Delegated Action of the Executive Director

Temporary Display at the National World War I Memorial's Sculpture Fountain

Pershing Park
Washington, DC

7682

Figure 1 Temporary sculpture scrim

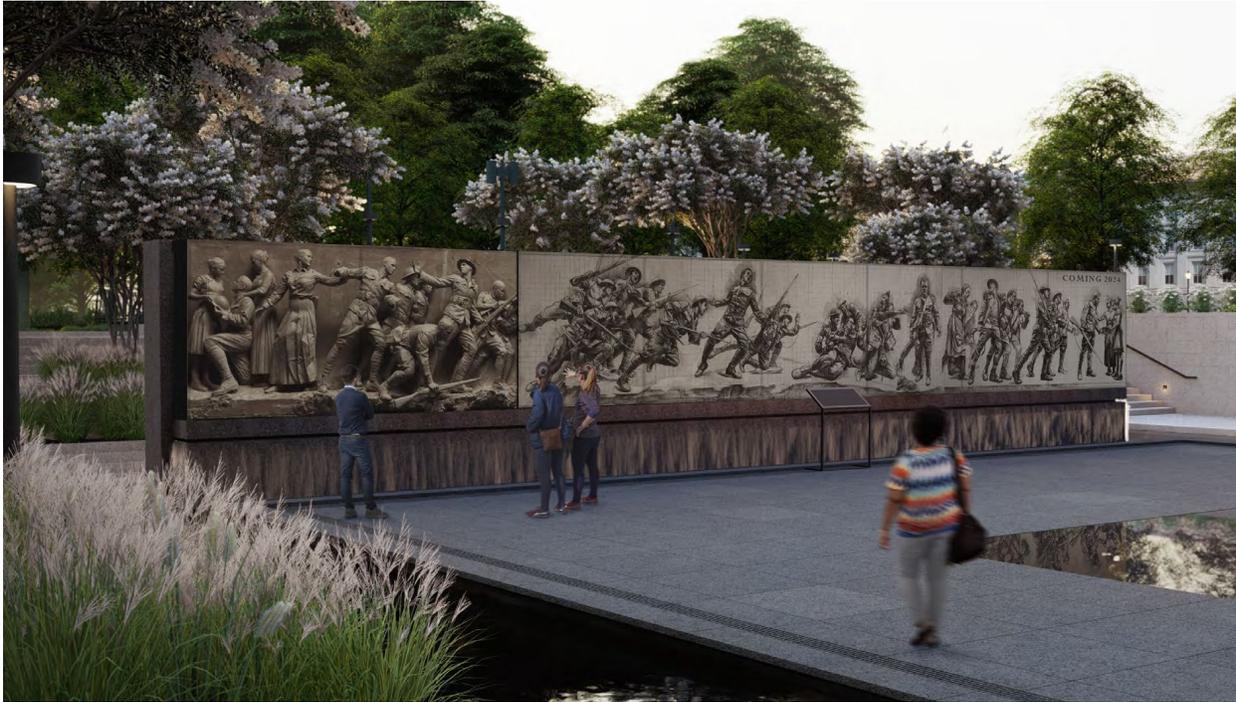
sculpture during the period of time between the opening of the park and installation of “A Soldier’s Journey.” In general, staff finds the proposed temporary display is in keeping with the design intent of the approved WWI Memorial and is an appropriate design element of the phased installation of the fountain sculpture.

Pursuant to delegations of authority adopted by the Commission on October 3, 1996 and per Public Law 93-166, Section 610(a), I approve preliminary and final site development plans for the temporary display at the National World War I Memorial's sculpture fountain, Pershing Park, Pennsylvania Avenue, NW, in Washington, DC, until the permanent sculpture is installed.
